# HORNSEA THREE OFFSHORE WIND FARM

Planning Inspectorate Reference: EN010080

# HORNSEA THREE OFFSHORE WIND FARM ORDER 2020 (AS AMENDED) ("the Order") SUBMISSION OF SANDBANKS IMPLEMENTATION PLANS UNDER PART 2 OF SCHEDULE 14 TO THE ORDER

Appendix 1: Assessment of SBIP against best practice guidance for developing compensatory measures in relation to Marine Protected Areas

Fig 1: JNCC map of NNSSR showing known debris

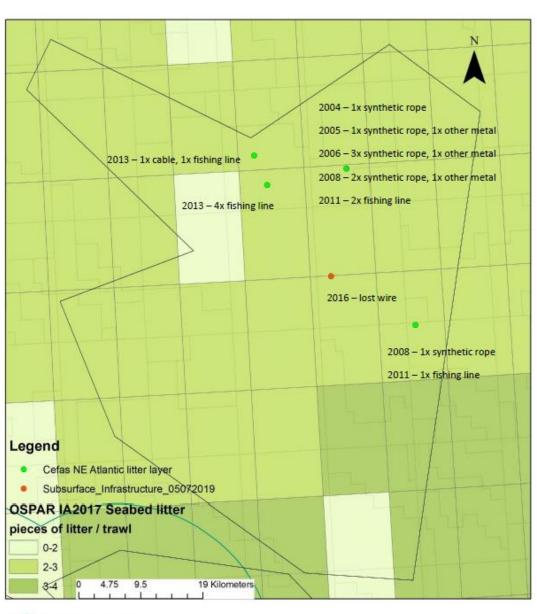
JNCC are particularly concerned that searching this area within NNSSR SAC may result in a limited amount of debris being removed. Fig 1 represents JNCC's understanding of the marine debris known within NNSSR SAC. This has been created from Oil and Gas Authorities subsurface infrastructure layer, Cefas's North East Atlantic Seafloor Marine Litter Data layer (where the litter is noted as being a fishing line, synthetic rope or metallic deposits) and OSPAR's IA2017 seabed litter layer showing relative number of litter items per square km. JNCC highlights the following:

- The majority of the litter is noted in Cefas's dataset. However, the latest of these points is 2013, and many are from 2008 2011. Given that the majority were noted as synthetic rope or fishing line, these pieces of debris may no longer be present, unless potentially tangled round infrastructure or buried.
- The pieces of litter / debris noted are outwith the topological sandbanks in the site.
- The pieces of litter / debris do not correspond to areas which JNCC believes indicate
  higher efforts of fishing in the site which doesn't link to the requirement to remove ghost
  fishing gear.

JNCC understand that there are linkages between physical conditions, sediment transport and areas of accumulation / burial / exposure of marine debris. However, we advise that based on our current knowledge, there is little litter or debris in the site that would be subject to transport or burial, and that we would not expect objects of a size greater than coarse sediment to be routinely transported in the site. Furthermore, we highlight that if areas of accumulation correspond to troughs between ripples, sandwaves or sandbanks, they may also correspond to areas of less represented biotopes or habitats, such as circalittoral mixed sediments, coarse sediments or Sabellaria reef. As such, operations that impact the seabed in these areas may prove challenging and will need to be fully considered and assessed by the MMO when the marine removal licence is applied for by the Hornsea Project Three. As part of that marine licence application, in-combination impacts with other plans and projects including the Hornsea Project Three DCO/dML will need to be undertaken.

Therefore, we do not believe that enough debris could be collected to make any discernible improvements to restoring Annex I sandbanks in NNSSR SAC, or to offsetting the long term/permanent sandbank habitat loss from the placement of cable protection.
